1 Replacing a Single Phase Smart Drive

If you are replacing a Single Phase Smart Drive with a Three Phase Smart Drive, there may be both wiring as well as software changes required. This Instruction Sheet outlines these requirements.

Figure 1-1: Front Panel, 230V Drives

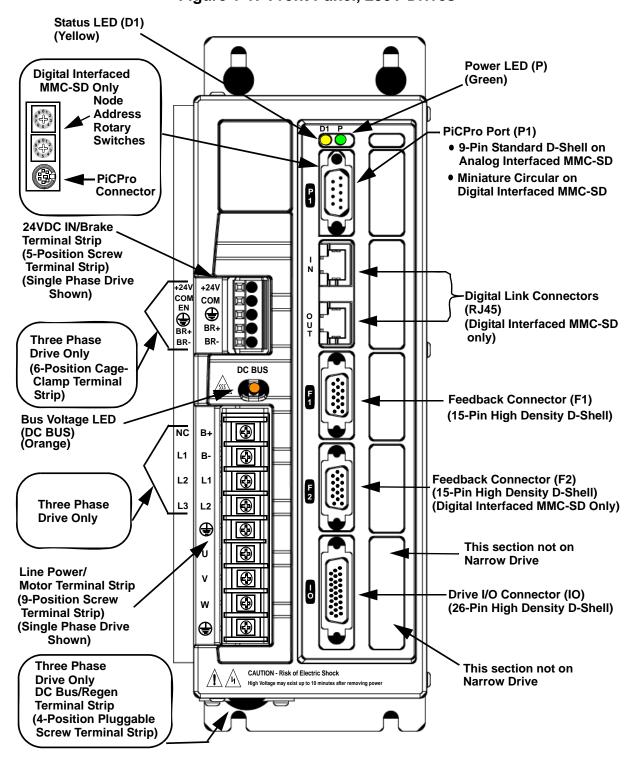
The right side of both the single and Three Phase Drives, containing the "D1" and "P" LED indicators, as well as the PiCPro, Digital Link, F1/F2 Feedback, and Drive I/O Connectors, are identical. Refer to Figure 1-1 on page 4

The left side of the Single Phase and the Three Phase Drive, as shown in Figure 1-1 on page 4, differ as follows:

- Single Phase drive connectors
 - 5-pin DC Power and Brake connector
 - 9-pin AC Power, Motor, and DC Bus connector
- Three Phase drive connectors
 - 6-pin DC Power, Brake, and Safe-off connector
 - 9-pin AC Power and Motor connector
 - 4-pin DC Bus and Regen Resistor connector (located on the bottom of the drive)
